DOT/FAA/ND-00/1

Heliport/Vertiport Design Deliberations 1997 - 2000

Robert D. Smith, Editor
Federal Aviation Administration
Washington, DC 20591

May 2001

Figure 1. Comparison of the Current 1 : 8 Approach/Departure Surface and the Two - Slope Approach/Departure Surface (Two Approach/Departure Paths)

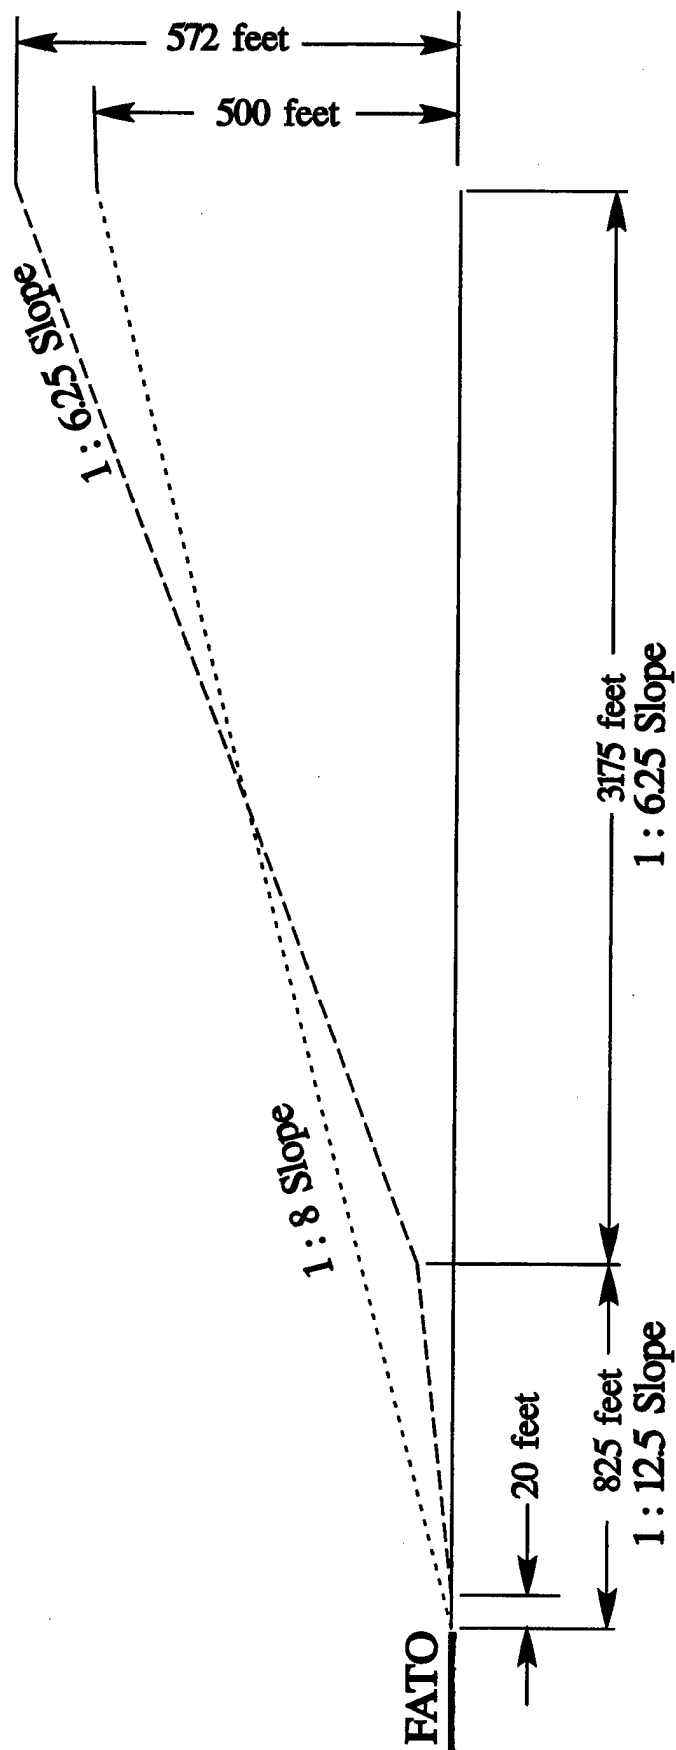
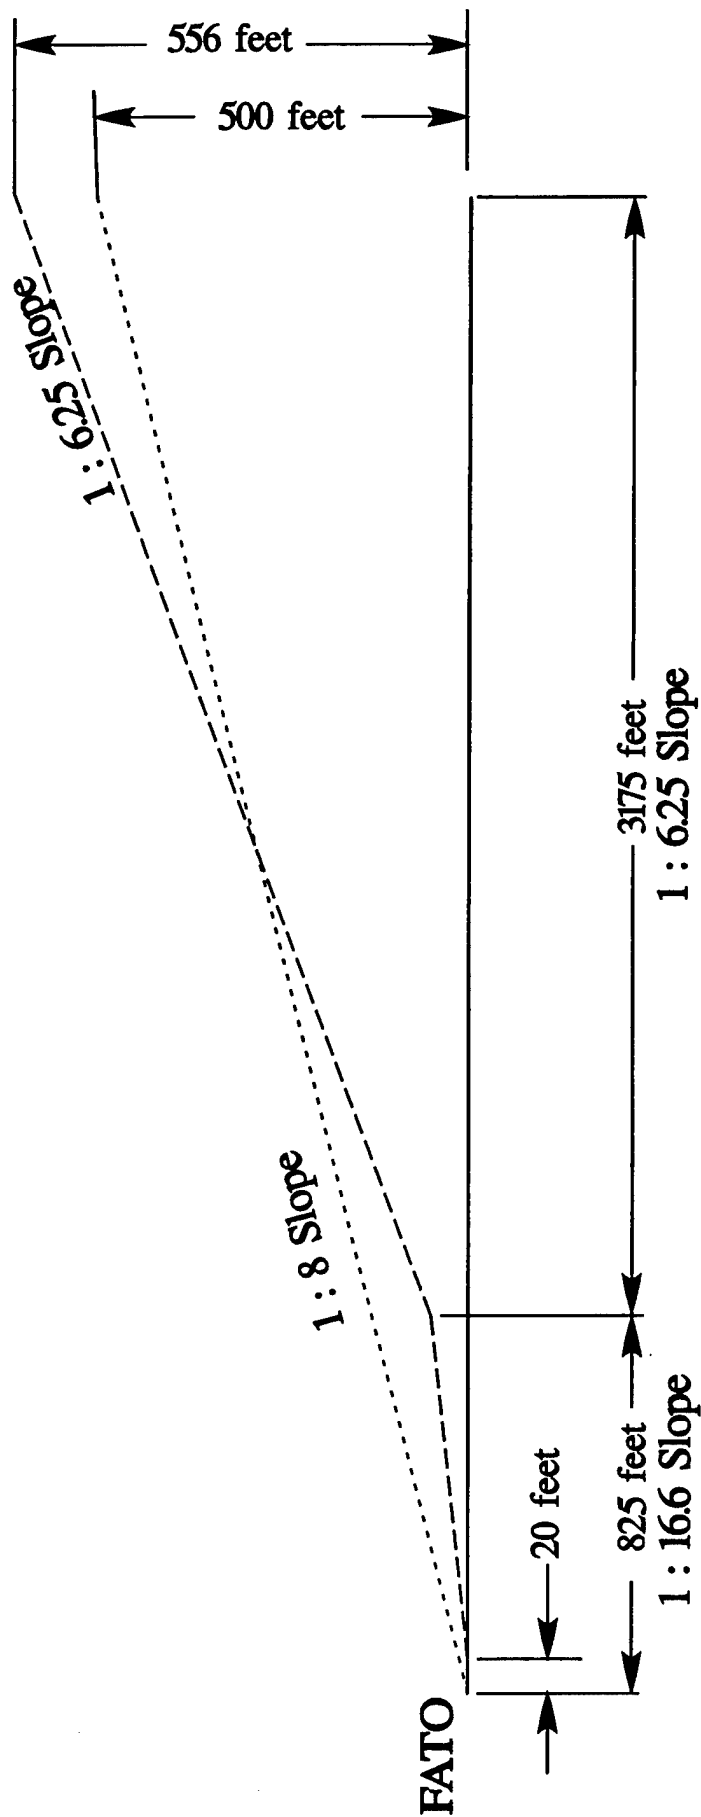
Adopt the two-slope approach/departure surface shown in figure 1.

The FAA would strongly prefer to adopt both figures 1 and 2 as Transport Canada has done. Unfortunately, we have been unable to reach a consensus on this point with Industry. As a compromise, the FAA and Industry have agreed to adopt figure 1. While this is less than ideal, it does provide an additional safety margin in comparison with the current Heliport Design AC recommendations. This additional airspace would also provide operators with additional operational flexibility.

Figure 1. Comparison of the Current 1 : 8 Approach/Departure Surface and the Two - Slope Approach/Departure Surface (Two Approach/Departure Paths)

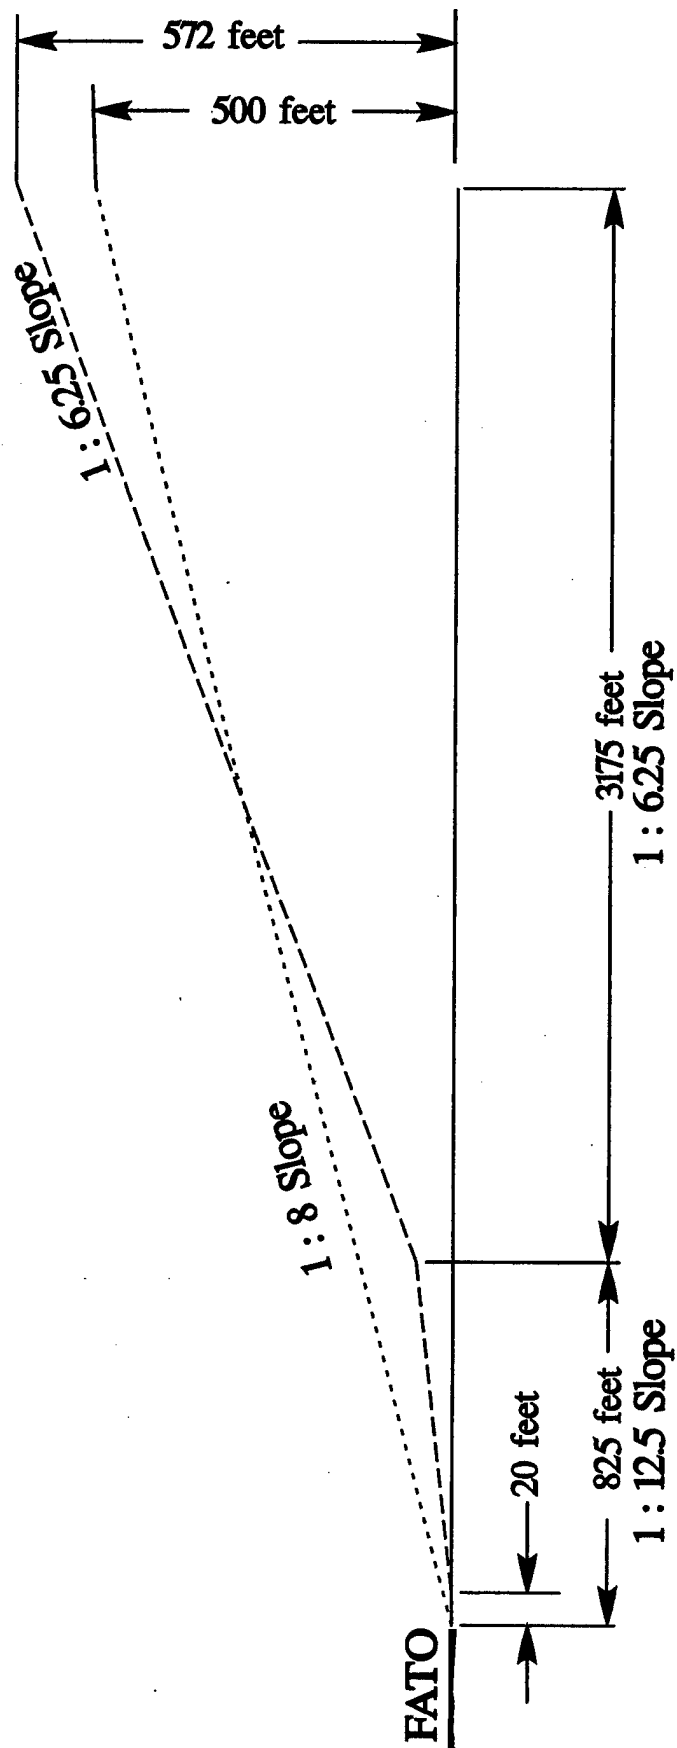
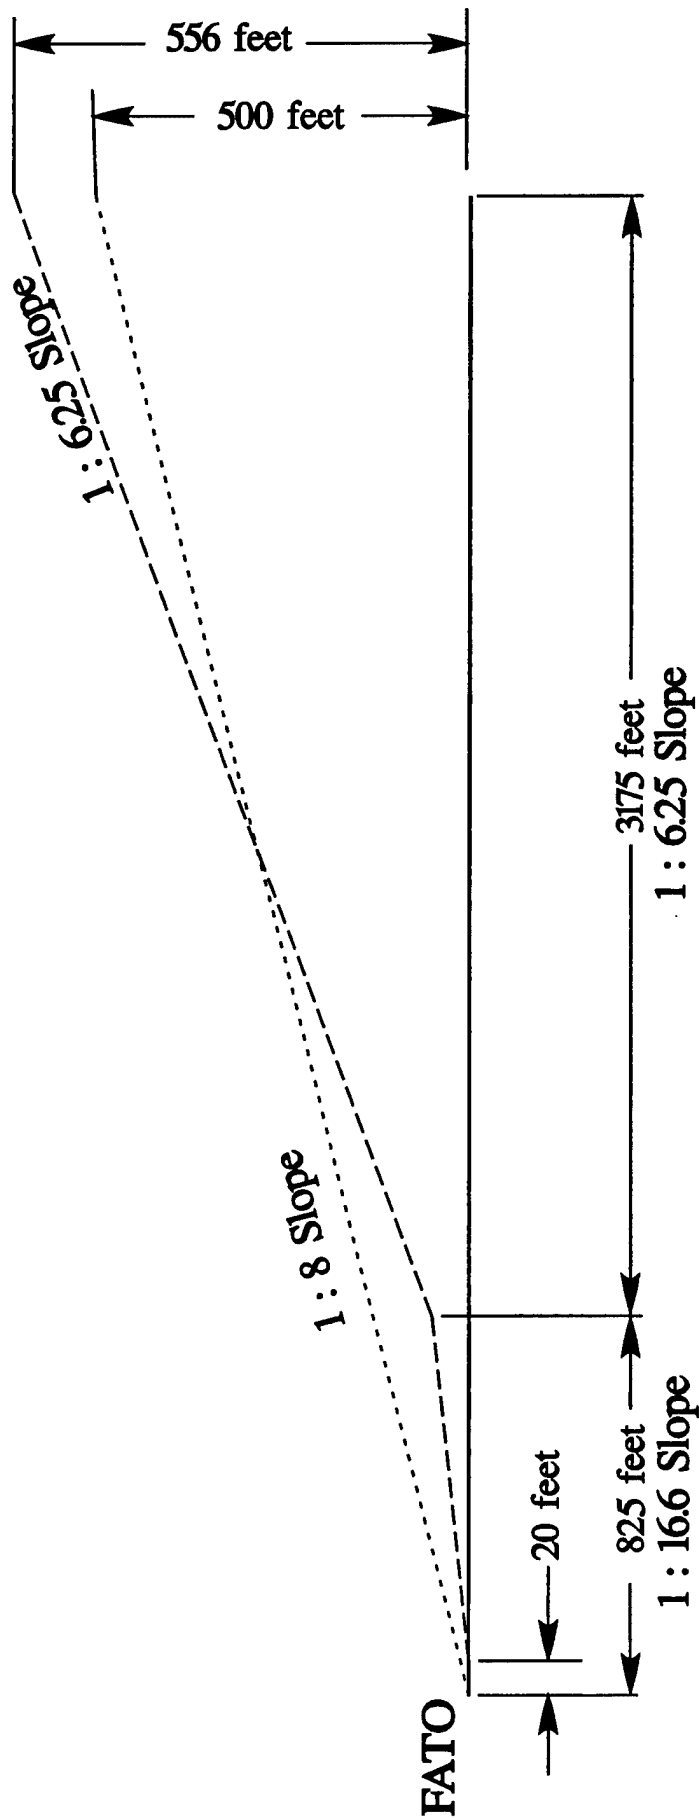
Subsequently, Industry has proposed that AC150/5390-2B be modified to require only one approach/departure path at certain heliports and that Figure 1 should also apply in such cases. This is an unappealing proposal. Transport Canada's rationale for distinguishing between these two scenarios is sound; it is a simple matter of physics. Helicopter performance deteriorates in the presence of a tailwind. At a heliport with only one approach/departure path, the pilot will sometimes be forced to operate with a tail wind. To maintain an adequate safety margin under such a scenario, the additional airspace of Figure 2 is appropriate.

The FAA would strongly prefer to adopt both figures 1 and 2 as Transport Canada has done. Figure 1 would be for heliports with two approach/departure paths (separated by 150 degrees or more). Figure 2 would be for heliports with only approach/departure path. Unfortunately, we have been unable to reach a consensus on this point with Industry. As a compromise, the FAA and Industry have agreed to adopt figure 1. While this is less than ideal, it does provide an additional safety margin in comparison with the current Heliport Design AC recommendations. This additional airspace would also provide operators with additional operational flexibility.

Figure 1. Side View of the Airspace Wherein
Marking and Lighting are Recommended

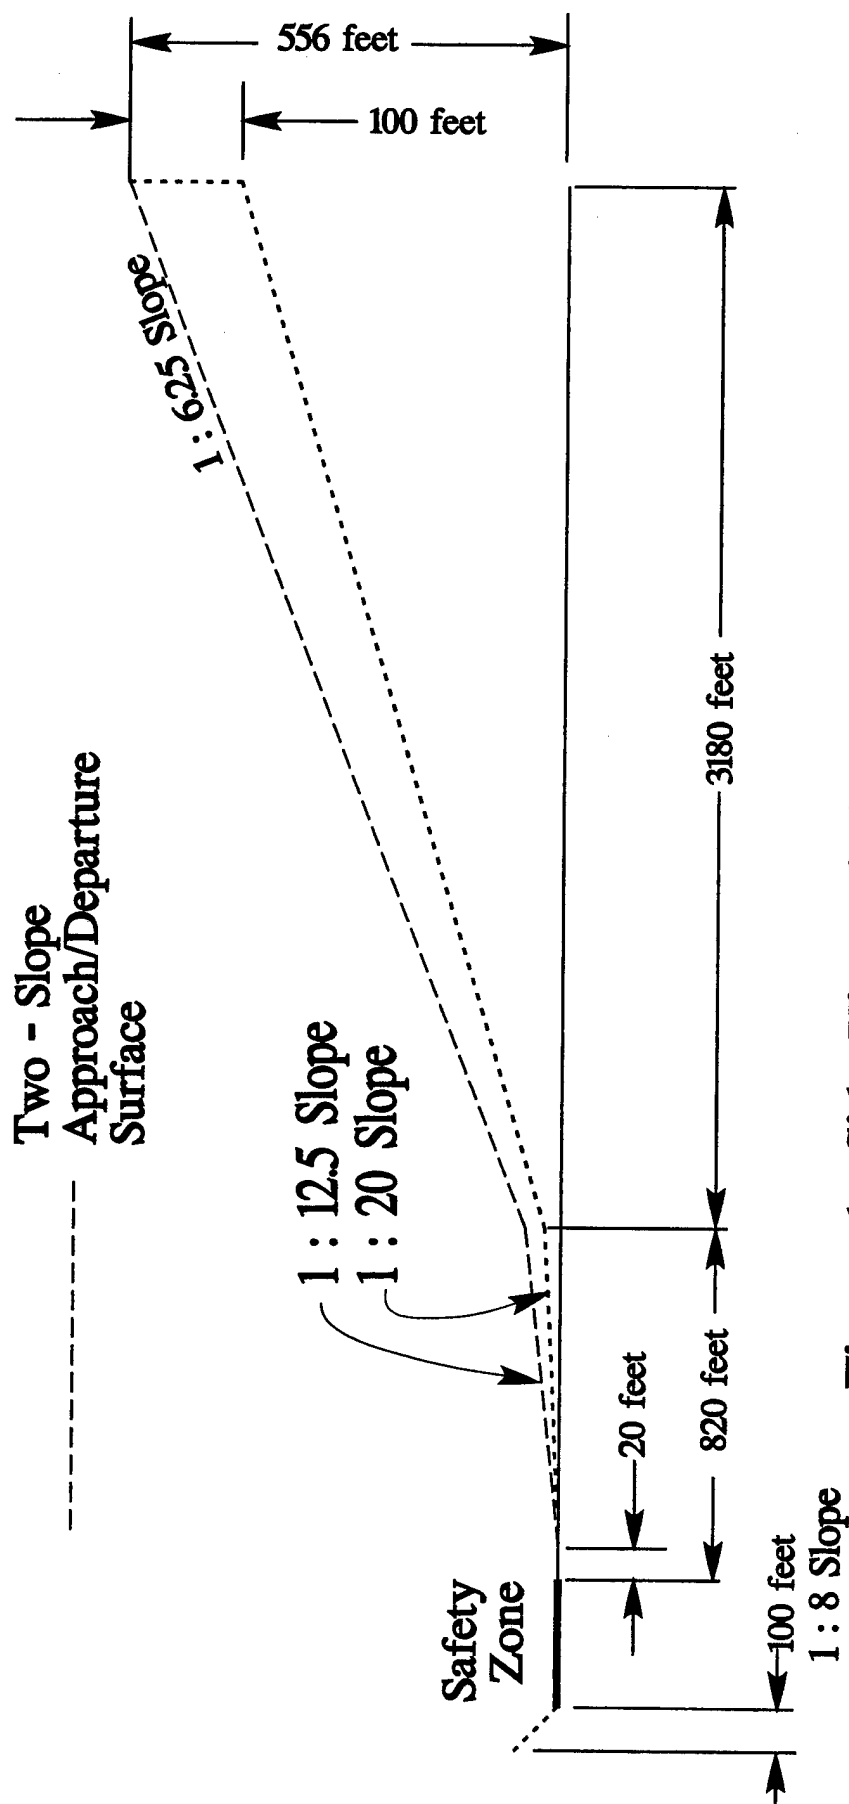
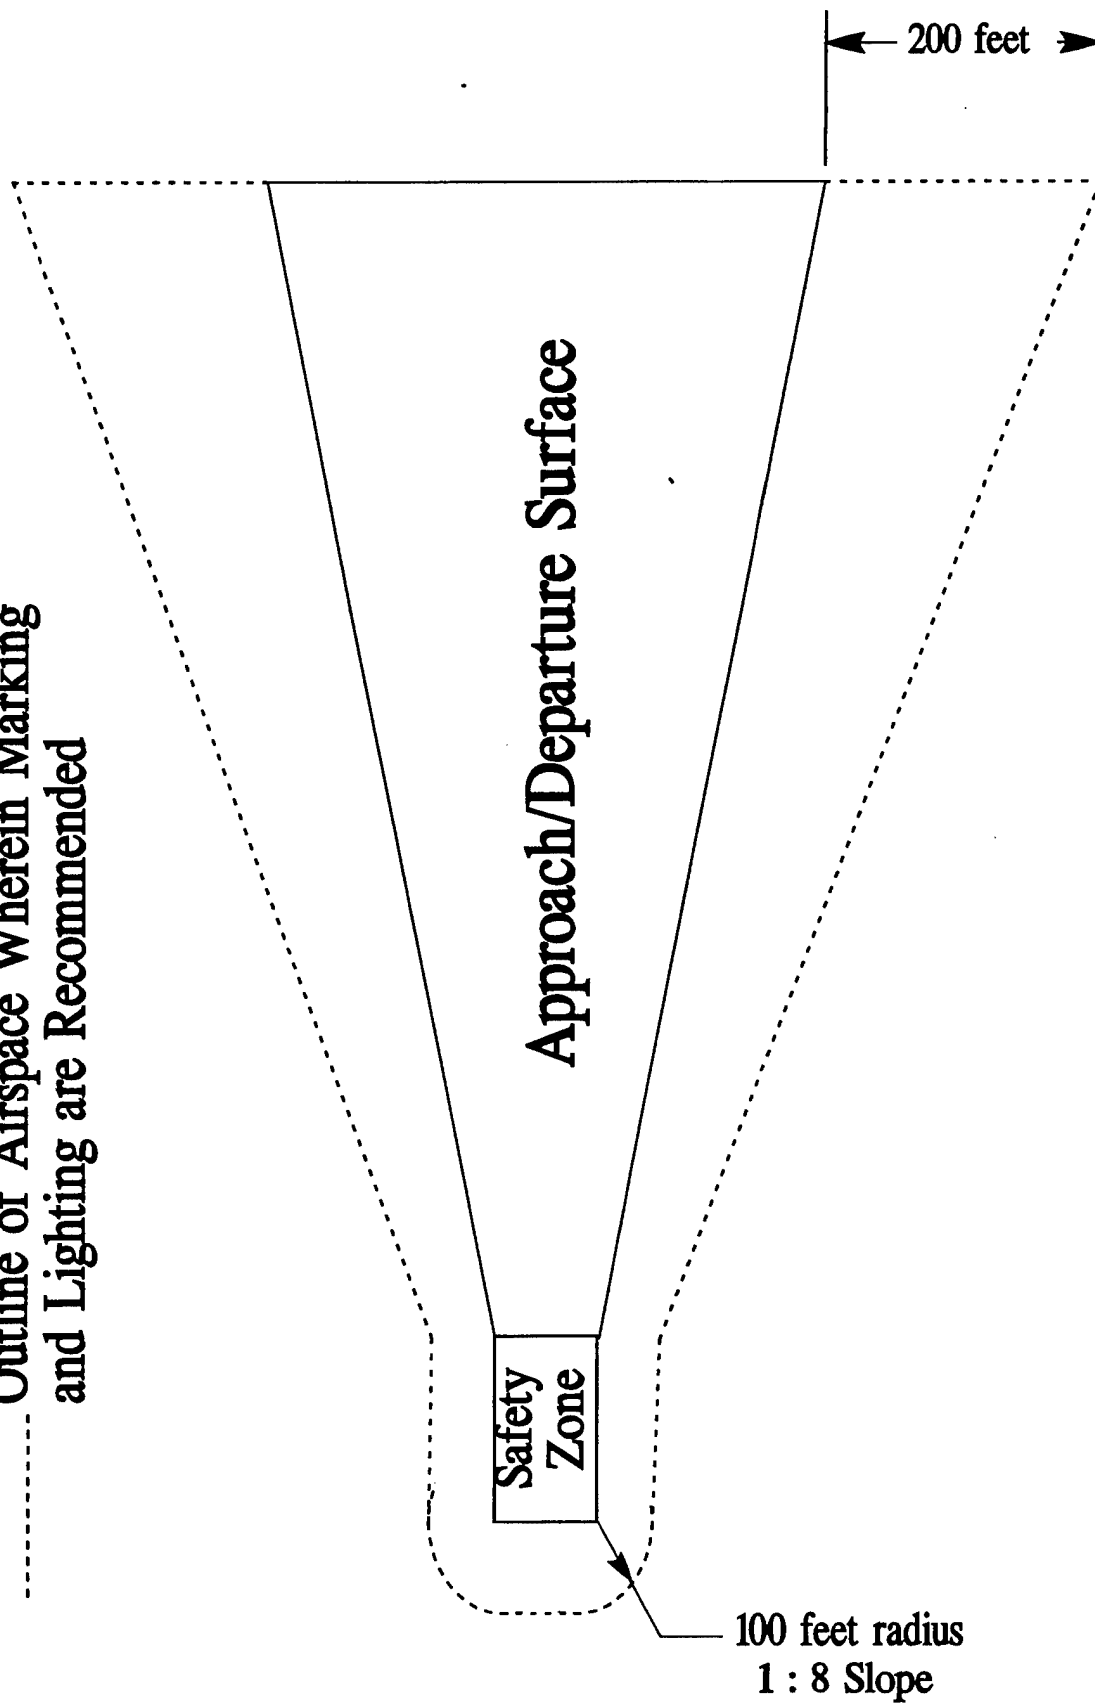
1. In the revised AC150/5390-2B, modify figures 2-14, 3-14, and 4-8 consistent with the attached Figures 1 and 2.
2. To avoid ambiguity in the revised AC150/5390-2B, the advisory circular text should discuss the various aspects of this airspace in greater detail, rather than simply referencing the figure as was done in AC150/5390-2A.
